Shire of Dardanup

ORDINARY MEETING

Wednesday, 29 August 2018
Commencing at 5.00pm

STRUCTURE PLAN MAP
LOT 383 PADBURY ROAD DARDANUP
26 / 03 / 2018

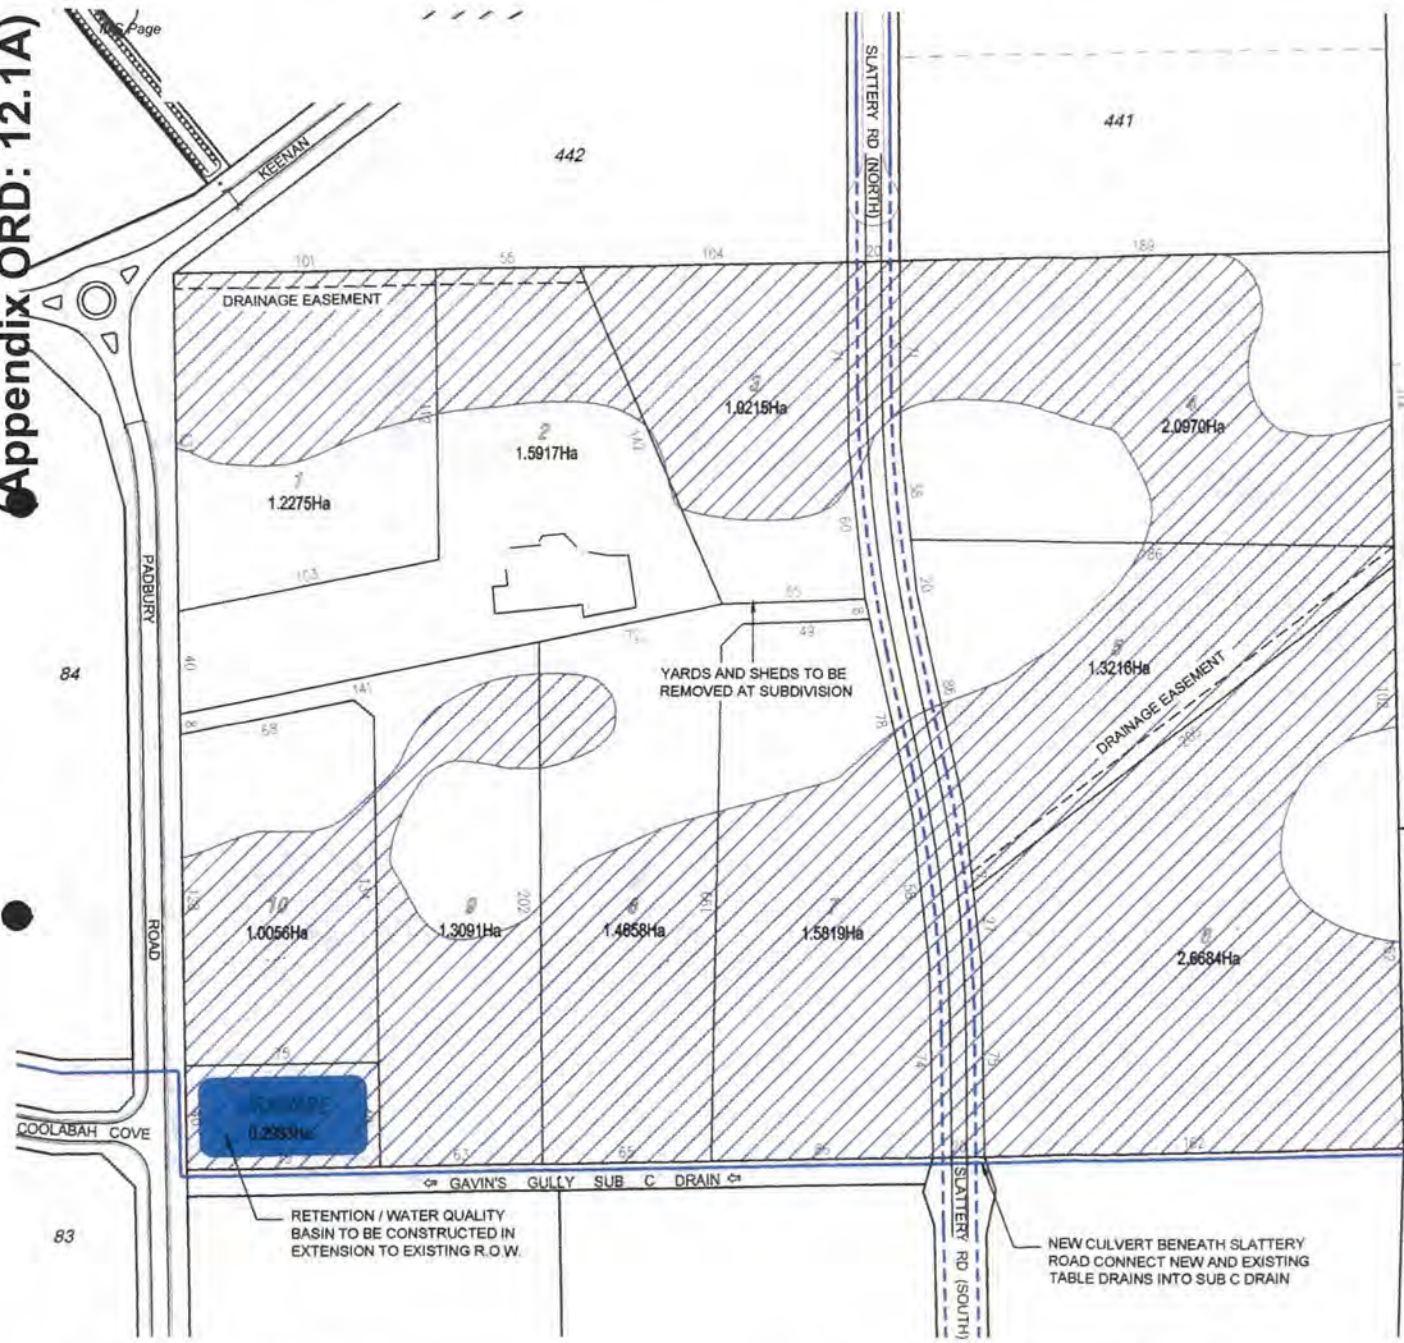
Element	Assessment	Action
Siting & design	<p>A2.1 – not demonstrated</p> <p>The structure plan map dated 26 October 2017 included within the scheme amendment report identifies ten proposed lots, and the BMP identifies eleven proposed lots on a "Proposed Subdivision" plan (Figure 5 page 10) - Clarification is required.</p> <p>The structure plan map dated 26 October 2017 identifies significant areas susceptible to seasonal waterlogging and inundation and unsuitable for development. These areas are identified as "building exclusion areas".</p> <p>The BMP does not identify Asset Protection Zones or more broadly, the 'developable areas' within each proposed lot. Developable areas are those areas in which a building can be built and include areas of BAL-29 and below. This should also include other site constraints, such as scheme setbacks and in this instance, areas outside of the "building exclusion areas".</p>	<p>Modification required.</p> <p>Please update all figures in the BMP to reflect the correct structure plan as necessary.</p> <p>Figure 10 of the BMP also needs to reflect the "building exclusion areas", and overlay areas of BAL 29 or below.</p>

Vehicular Access	<p>A3.4 – not demonstrated</p> <p>In bushfire prone areas, lots with battle-axe access legs should be avoided because they often do not provide two-way access and egress for residents and may be easily blocked by falling trees or debris during a</p>	<p>Not demonstrated.</p> <p>Please provide justification for non-compliance or modify the structure plan accordingly.</p>

bushfire event. DFES recommends the structure plan be modified to ensure through access thereby avoiding the need for battle-axe lots.	
Water	A4.2 – not demonstrated The BMP at 6.2.4 details the requirement for a dedicated 50,000 litre water tank supply. It goes on to detail that <i>"Council have instructed that the water tank is to be provided at the West Dardanup fire brigade station located on Garvey Road"</i> . The BMP also details that this location exceeds the maximum two-kilometre distance as required by the Guidelines.	Not demonstrated Please provide justification from the local government for the location of the water tank or modify the location accordingly.

- The Stormwater Management Plan information (in the Structure Plan report) states that the 1:100 flood level is estimated at 18.6 m AHD (where Sub C Drain enters the main gully), but no details have been provided as to how the estimation was made. It may therefore be possible that the lots finished floor level could be insufficient posing a flooding risk.

- In the absence of 'whole of catchment information', there is a stormwater management risk that the infrastructure (i.e. culvert beneath Slattery Road, drainage easements and detention basin) proposed in the structure plan may not be of sufficient capacity to attenuate increased flows from adjacent development resulting in increased flooding risk.

- The Building Exclusion Area, drainage easements and drains (as identified in the Structure Plan) should also exclude on-site sewage disposal areas, noting that in accordance with section 6.2.2 of the Government Sewerage Policy (Nov 2017), an on-site sewage disposal system is not to be located within 100 metres of a drainage system (that discharges directly into a waterway) and any area subject to inundation and/or flooding in a 10 per cent Annual Exceedance Probability (AEP) rainfall event.

- More details should be provided regarding the sizing and capacity of the detention basin (including drainage easements and culvert); in view of the ensuring sufficient capacity to service the structure plan area, and also future adjacent developments.

- That additional detail be provided in the Structure Plan supporting information (i.e. Stormwater Management Plan) to mitigate against the above risks.
- The Shire commissions a drainage and groundwater study over the entire Crooked Brook/Dardanup West Structure Plan to:
 - investigate the need for drainage upgrades as outlined in the Hydrological Review of the Crooked Brook Structure (JDA 2005), and
 - develop a more rigorous understanding the groundwater regime to enable on-site effluent system applications to be appropriately assessed.

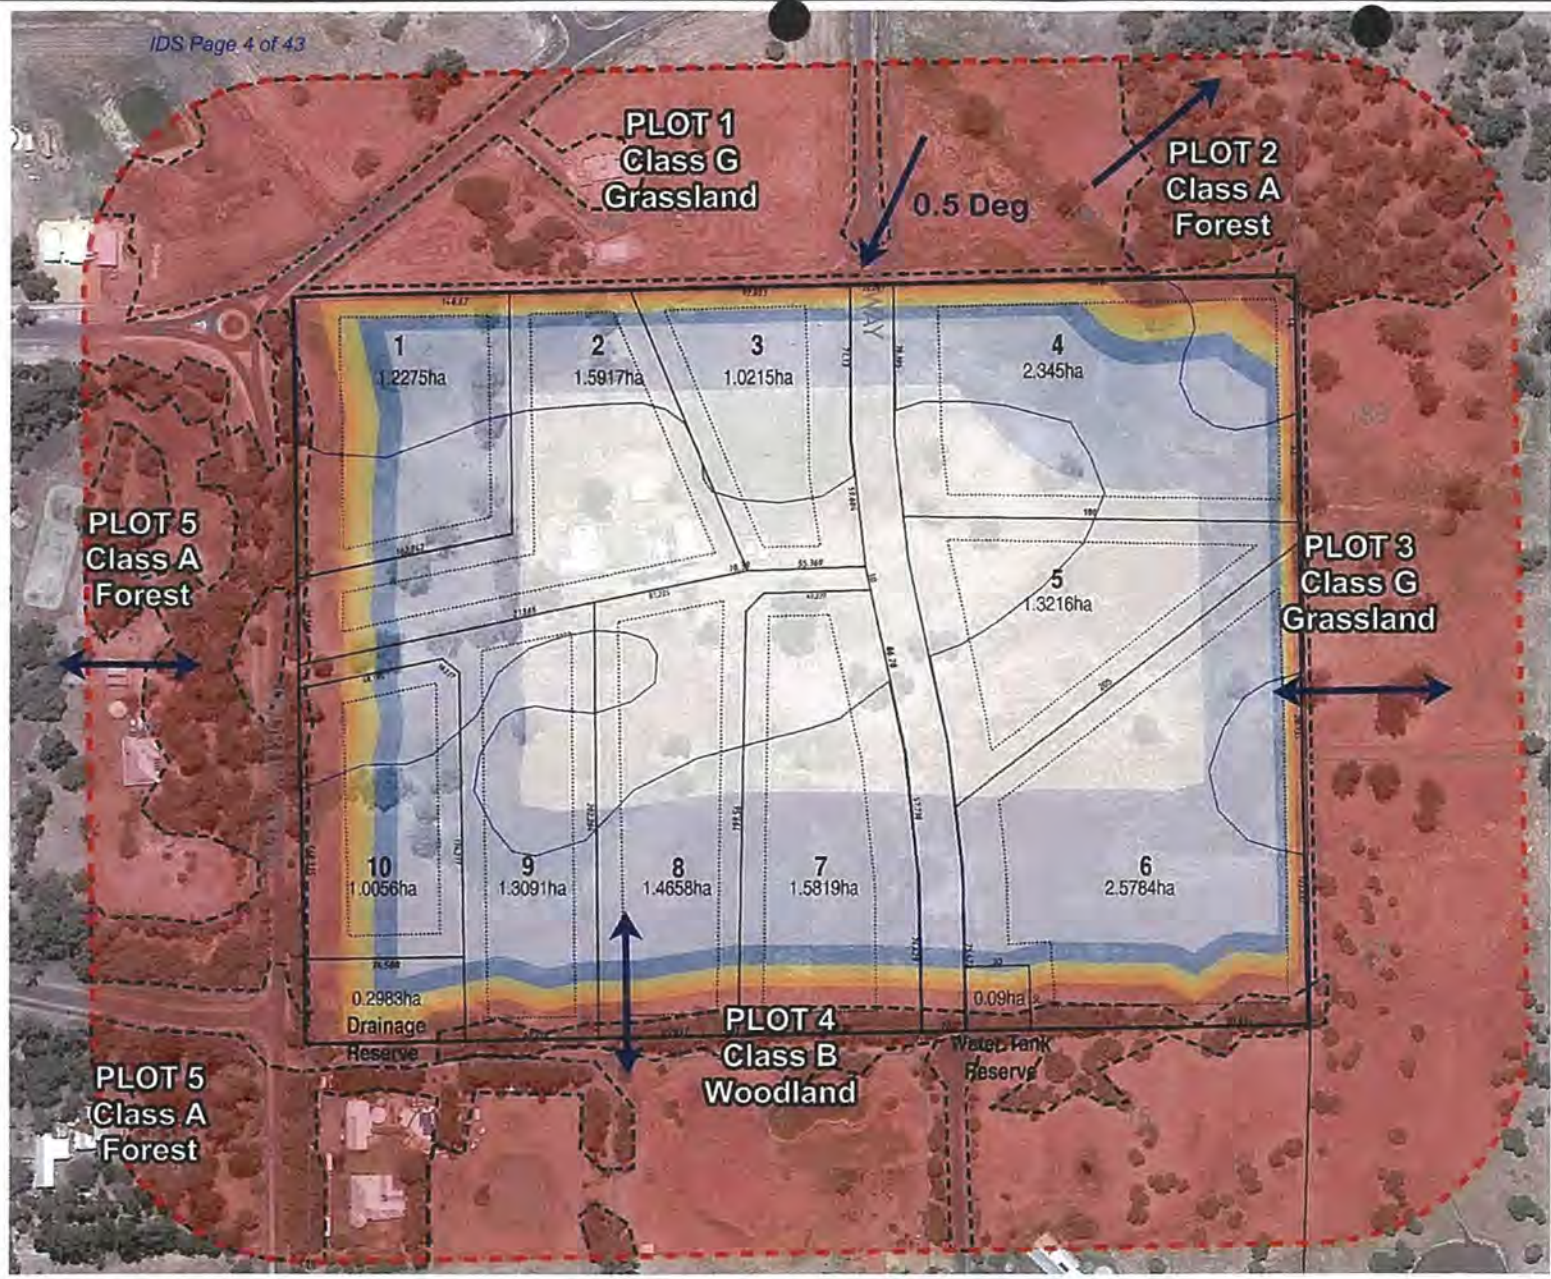
The suggestion of the Dept. that a road take the place of the battle axe legs is considered unnecessary. There are more than enough east-west roads in this locality. The Shire do not want a road. The above measures satisfy the concerns of the Dept.

The location of a tank site is a strategic issues between the Shire and DF&ES. If it finally resolved to have a site on Lot 383 then the proponent will designate an agreed site on the Slattery Road extension. The size of the site and the reserve description will need to be determined.

FIGURE 8
BAL CONTOURS

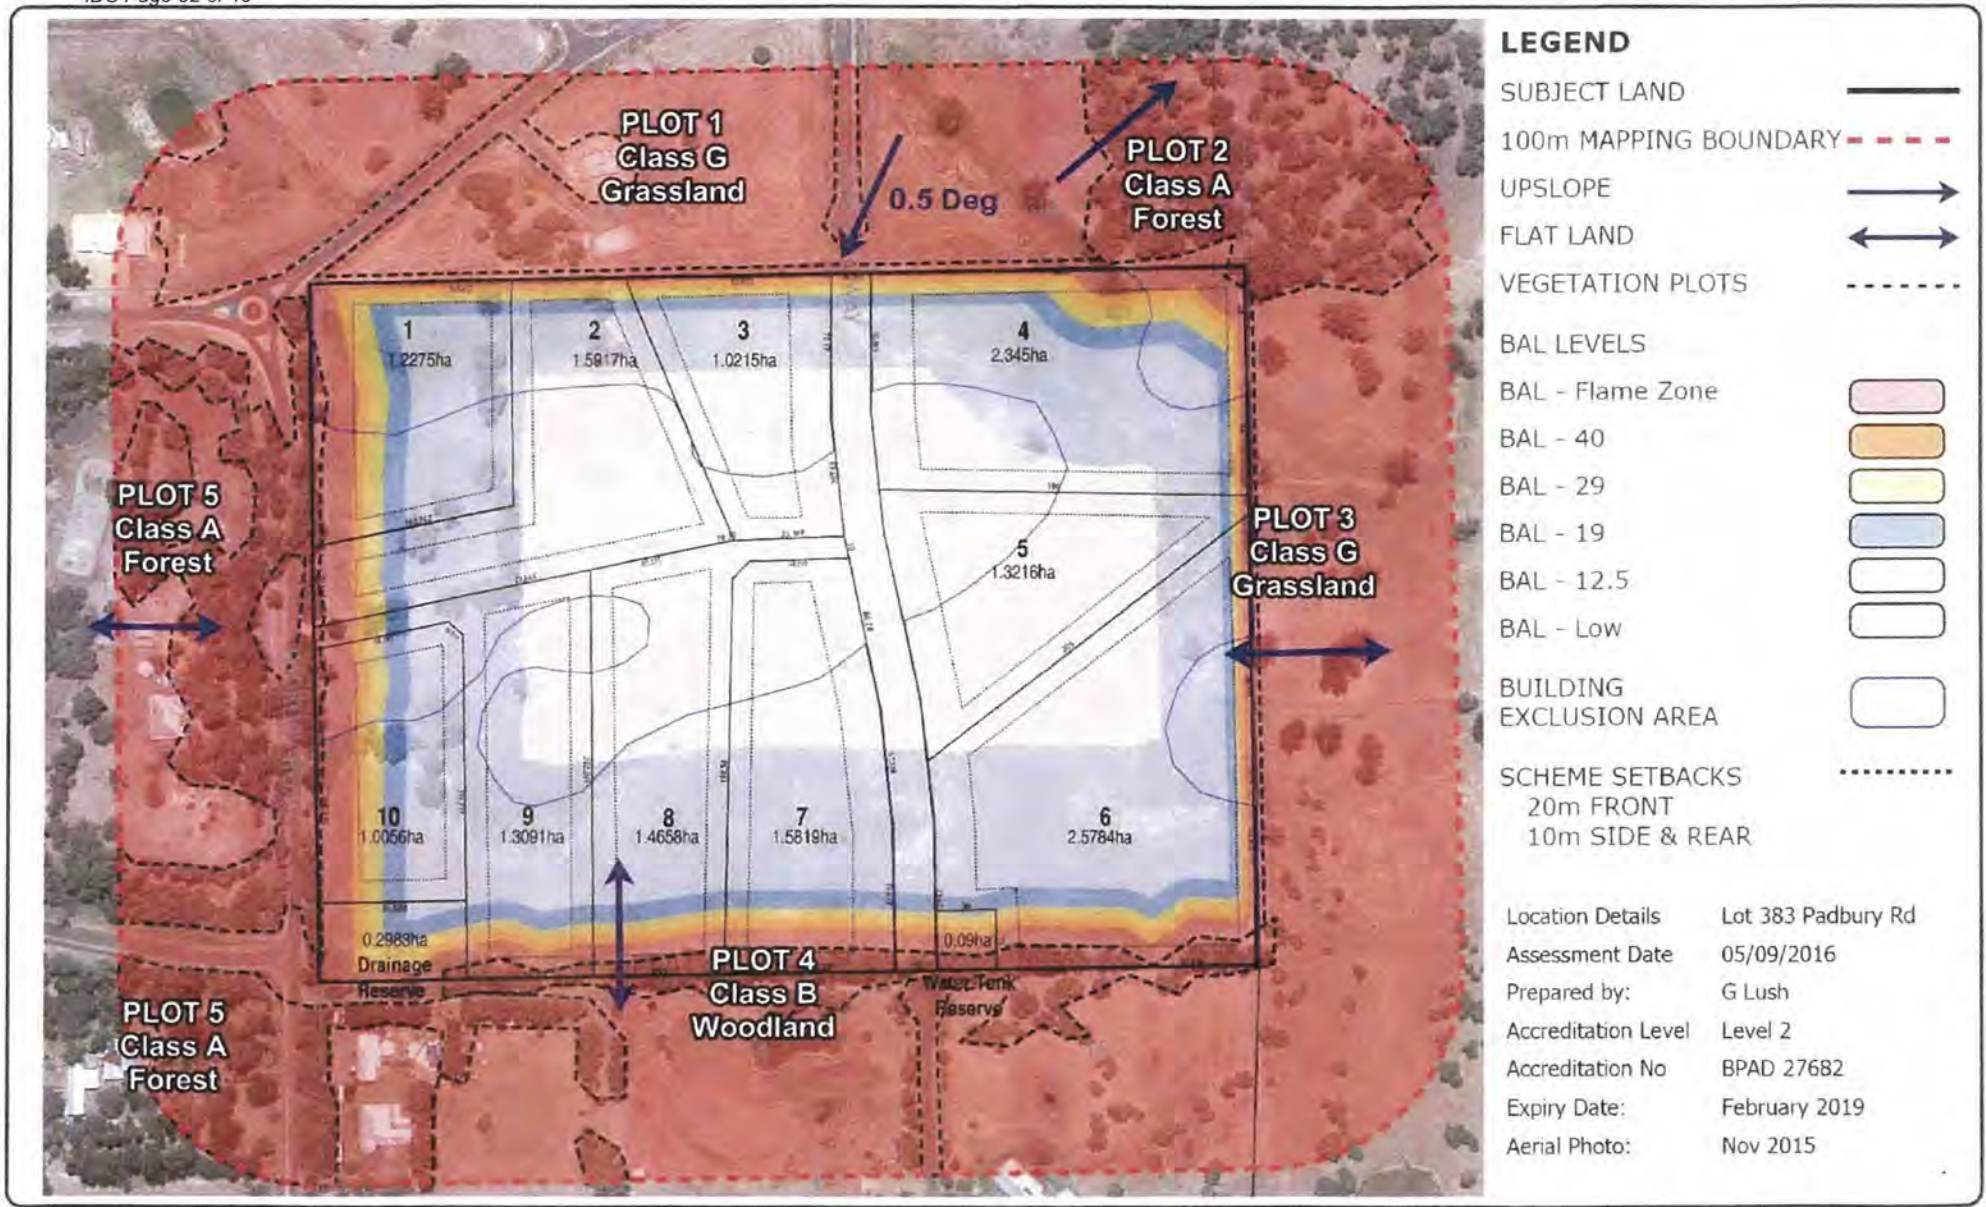
Element	Assessment	Action
Siting & design	<p>A2.1 – not demonstrated</p> <p>The structure plan map dated 26 October 2017 included within the scheme amendment report identifies ten proposed lots, and the BMP identifies eleven proposed lots on a "Proposed Subdivision" plan (Figure 5 page 10) - Clarification is required.</p> <p>The structure plan map dated 26 October 2017 identifies significant areas susceptible to seasonal waterlogging and inundation and unsuitable for development. These areas are identified as "building exclusion areas".</p> <p>The BMP does not identify Asset Protection Zones or more broadly, the 'developable areas' within each proposed lot. Developable areas are those areas in which a building can be built and include areas of BAL-29 and below. This should also include other site constraints, such as scheme setbacks and in this instance, areas outside of the "building exclusion areas".</p>	<p>Modification required.</p> <p>Please update all figures in the BMP to reflect the correct structure plan as necessary.</p> <p>Figure 10 of the BMP also needs to reflect the "building exclusion areas", and overlay areas of BAL 29 or below.</p>

Figure 8 also shows the building exclusion areas and the minimum boundary setbacks provided for in the Planning Scheme ie 20m front boundary; 10m side and rear boundaries. There are minor portions of lots which have a BAL-40 or BAL-FZ rating encroaching past these setbacks. However, any BAL assessment that results in a BAL 40 or FZ rating will then trigger a Development Application pursuant to Clause 78D Part 10A of the Planning and Development (Local Planning Schemes) Regulations 2015. As part of this application local government can require the dwelling to be sited so as to achieve a BAL-29 rating.
